MONTGOMERY COUNTY HISTORIC PRESERVATION COMMISSION
STAFF REPORT

Address:	102 East Kirke Street, Chevy Chase	Meeting Date:	11/12/2025
Resource:	Outstanding Resource Chevy Chase Village Historic District	Report Date:	11/5/2025
Applicant:	Britt & Will Williams (Luke Olson, Architect)	Public Notice:	10/29/2025
Review:	HAWP	Tax Credit:	n/a
Permit No.:	1067931 REVISION#4	Staff:	Dan Bruechert
Proposal:	Chimney Removal

The applicant proposes to remove an existing chimney and repair the roof.

ROOF PLAN

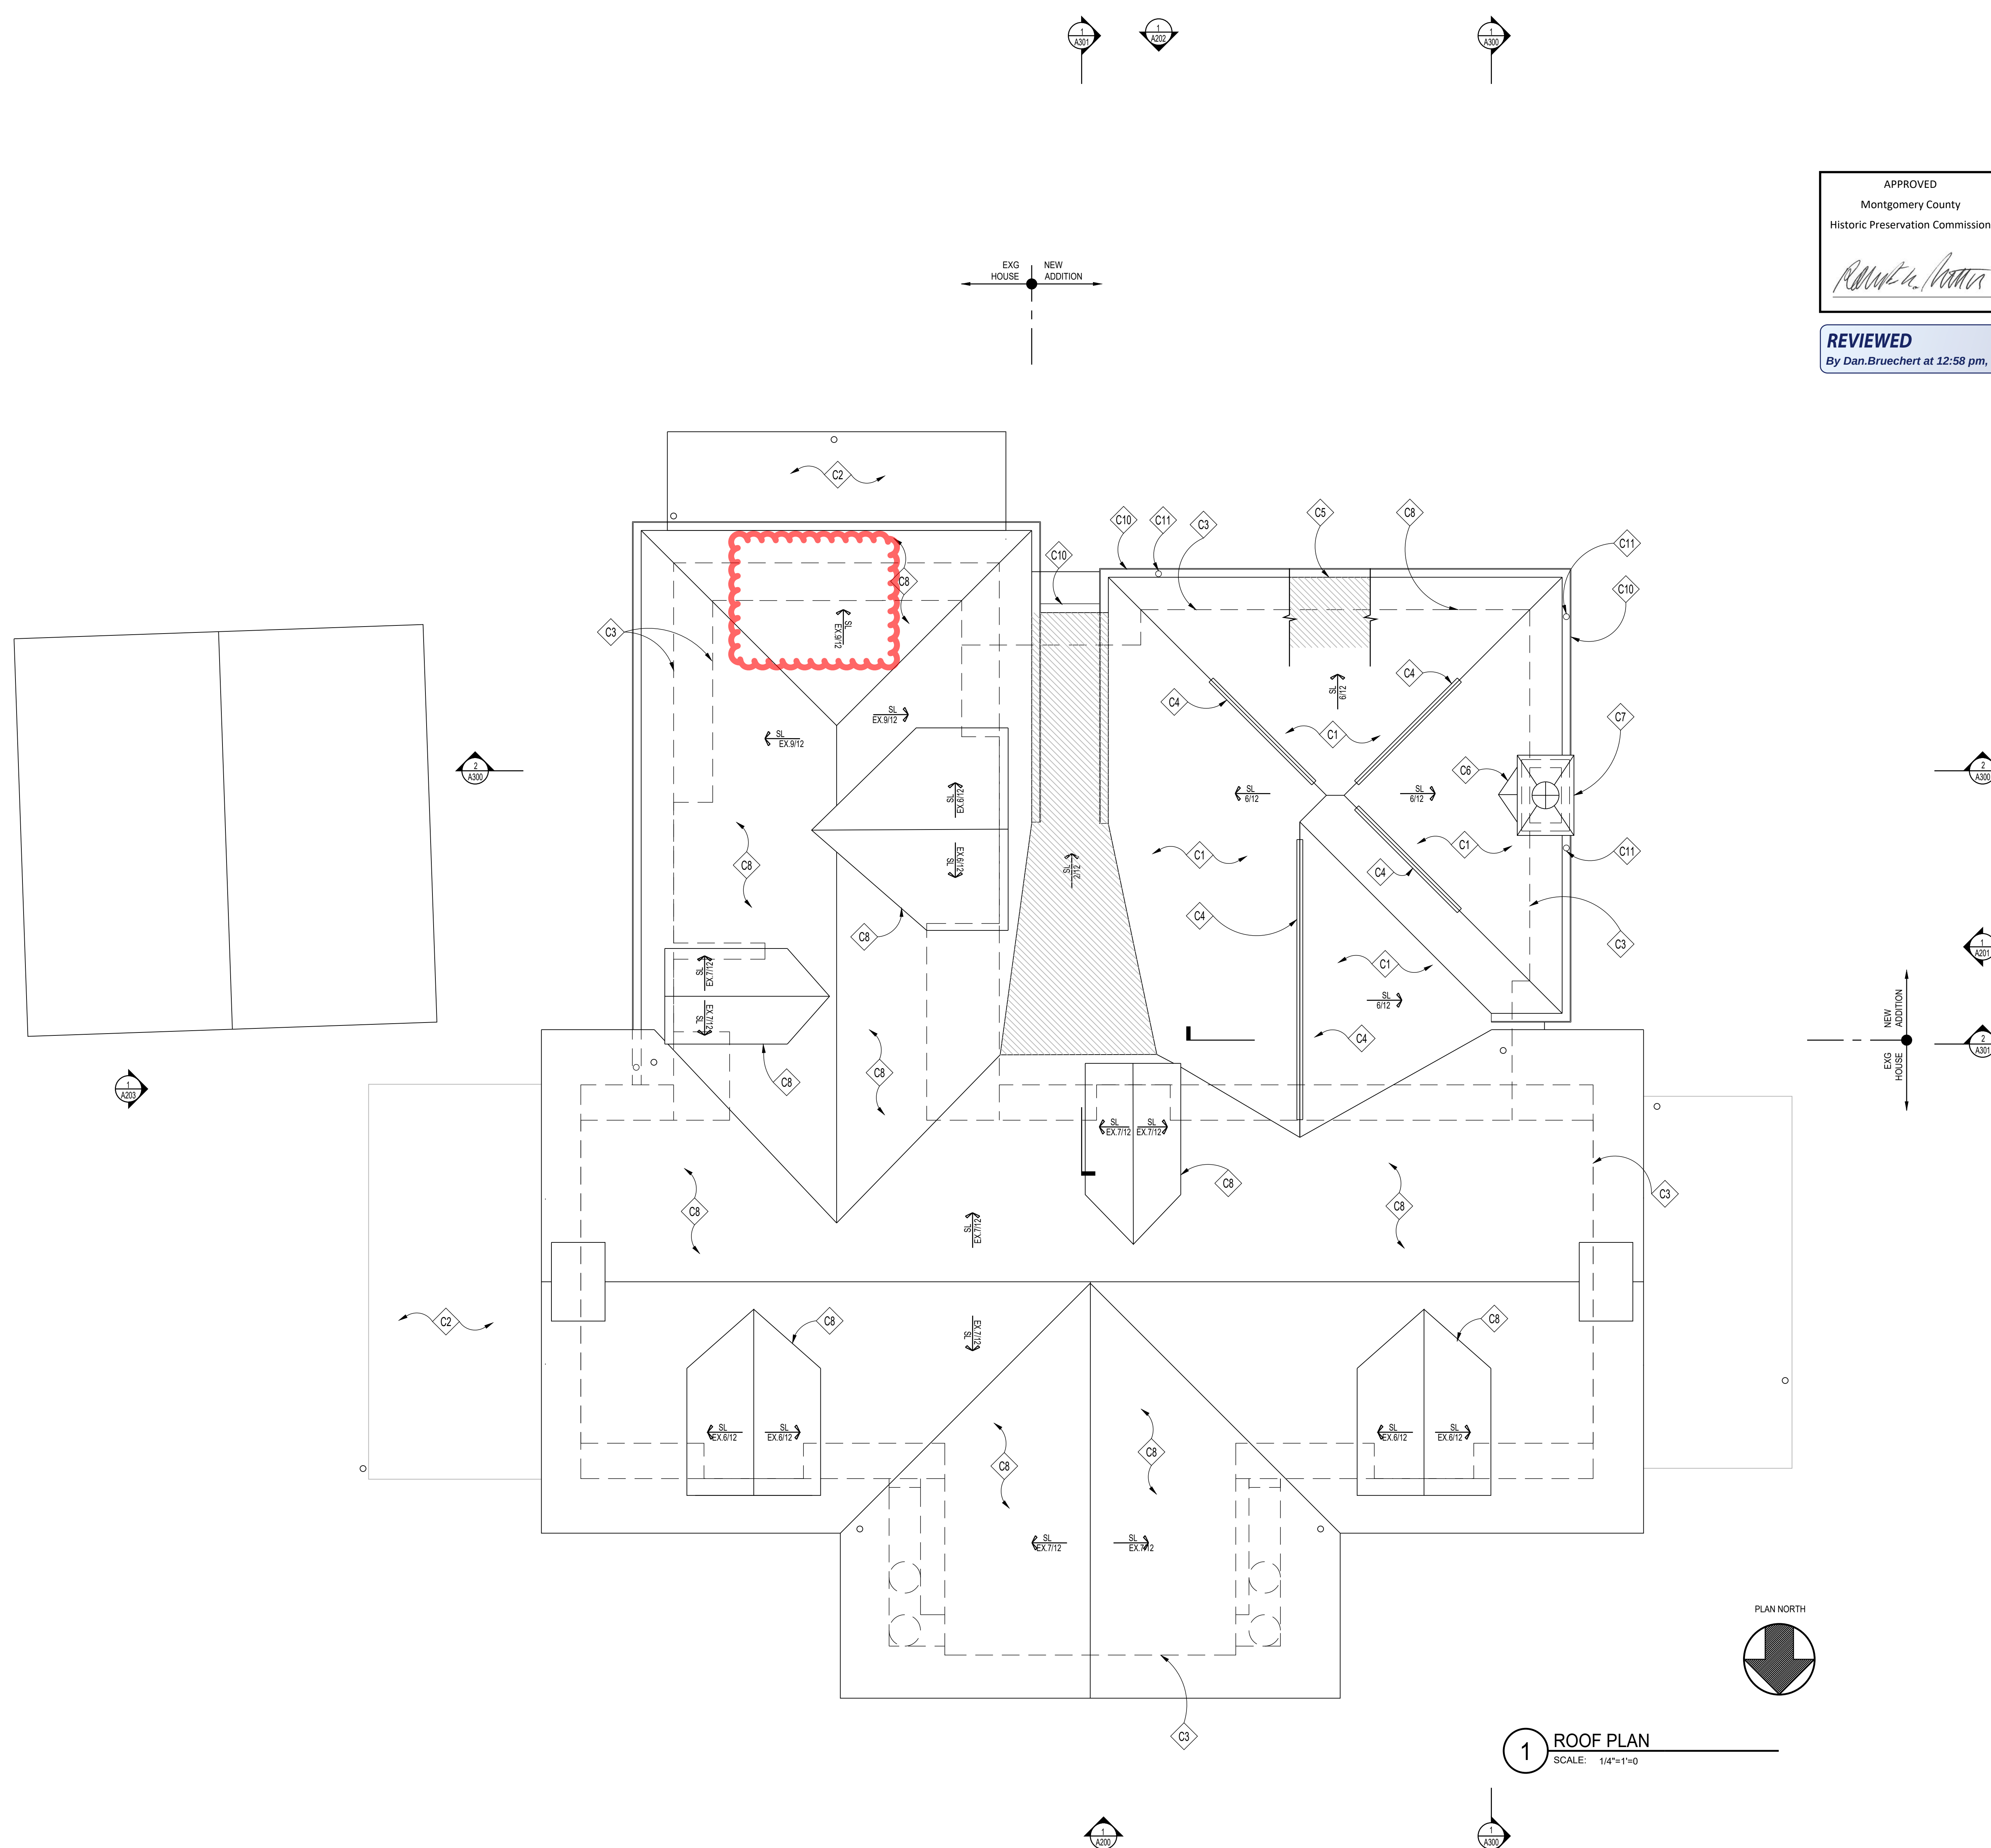
The subject property has three chimneys. There is a chimney at either gable end of the main block of the house and a chimney at the rear of the projecting-L. During construction, the applicant identified substantial damage to the rear chimney. Further investigation by a structural engineer (letter attached)

determined that chimney had deteriorated to the point it was, “unable to resist the tensile stresses at the base of the chimney.” And that is considered too tall for an unreinforced chimney due to its tall, slender proportions. The applicant proposes to remove this chimney and to repair the roof.

Staff finds that based on the analysis by the structural engineer that the existing chimney has deteriorated beyond repair and needs to be demolished. The question then is, what is the appropriate treatment for the chimney’s location?

Staff finds the rear chimney is narrower than the gable end chimneys but does have the same crown design, which shows more consideration went into the design and construction of this chimney than a purely utilitarian brick or block chimney. Additionally, because the subject property is on a corner lot, the rear chimney is visible from the public right-of-way. Staff finds additional consideration should be given to the proposal due to the subject property’s designation as an ‘Outstanding Resource.’ According to the *Design Guidelines*, these categories are established to provide the HPC with guidance as to the architectural and historical significance... [and] structures with the highest degree of importance should

Considering the design significance of the chimney and its ‘Outstanding Resource’ categorization, and because the proposed change is in a location that is visible from the public right-of-way, Staff recommends the HPC add a condition to the HAWP that requires the chimney, above the roofline, to be reconstructed. Because of the stucco exterior, Staff finds that the chimney could be constructed out of masonry or framed, provided the exterior is stuccoed to match the house and the crown is replicated. With the recommended condition, Staff finds the HAWP is appropriate under 24A-8(b)(1), the *Design Guidelines*, and *Standards #2* and *5*.

1. The chimney above the roofline must be replicated to match the dimensions and appearance of the historic chimney. Documents detailing the construction of the chimney must be submitted to Staff before the issuance of the final HAWP approval documents;
